Item ID: D206-667-107BL Accept *N900040100* Setup Start *NS1*
 Revision ID: Stop *NS2*
 Item Name: Fwd Crosstube - Mid Height 206L / L1 / L3 / L4, Blue
 Start Date: 10/28/2015 Start Qty: 1.00 *1* Cust Item ID:
 Required Date: 10/28/2015 Req'd Qty: 1.00 *1* Customer:
 Reference:

DRAWING NO. D206-667-147
REV. A
SHEET 1 OF 4

DRAWING NO. D206-667-147	TITLE CROSSTUBE ASS'Y (206L MID FWD)	REV. A	DART AEROSPACE LTD ENGINEERING ORDER		D.E.O. NO. D206-667-147-A-1	SHEET NO. SHEET 1 OF 1	SCALE NTS
DRAWN <i>Q</i>	CHECKED <i>ASS</i>	MFG. APPR. <i>JB</i>	APPROVED <i>MD</i>		DE APPR. <i>MD</i>		
DATE 11.07.15	DATE 11.07.20	DATE 11.07.21	DATE 11/07/21		DATE 11.07.21

DRAWING NO. D206-667-147	TITLE CROSSTUBE ASS'Y (206L MID FWD)	REV. A	DART AEROSPACE LTD ENGINEERING ORDER	D.E.O. NO. D206-667-147-A-2	SHEET NO. SHEET 1 OF 1	SCALE NTS
DRAWN AJS	CHECKED	MFG. APPR.	APPROVED	DE APPR.		
DATE 12.08.02	DATE 12.08.02	DATE 12.08.02	DATE 12.08.02	DATE 12.08.02	DATE 12.08.02

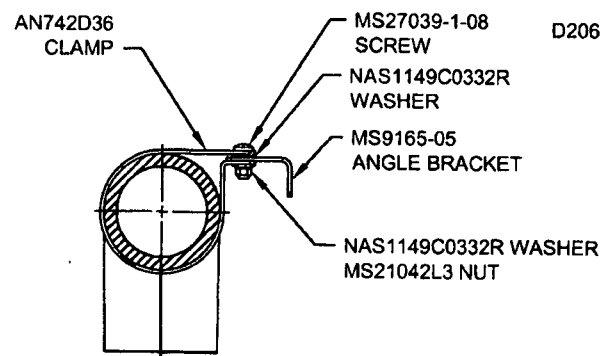
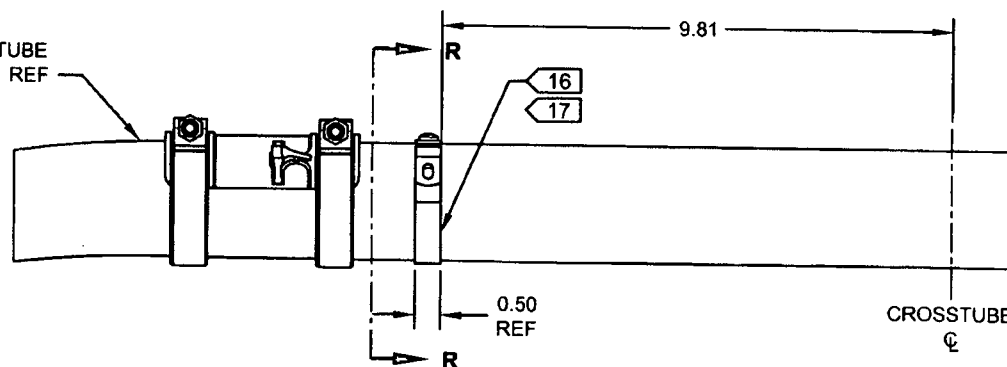
ADD ELECTRICAL GROUNDING STRAP

ADD

- 16) MASK AREA UNDER CLAMP PRIOR TO PAINTING
- 17) SEAL EDGES WHERE AN742D36 CLAMP MEETS WITH THE CROSSTUBE USING SIKAFLEX-241/-291 OR MIL-S-8802 CLASS B2 OR PROSEAL 890 SEALANT
- 18) PERFORM RESISTANCE CHECK TO ENSURE MAX RESISTANCE IS 10 MILLIOHMS
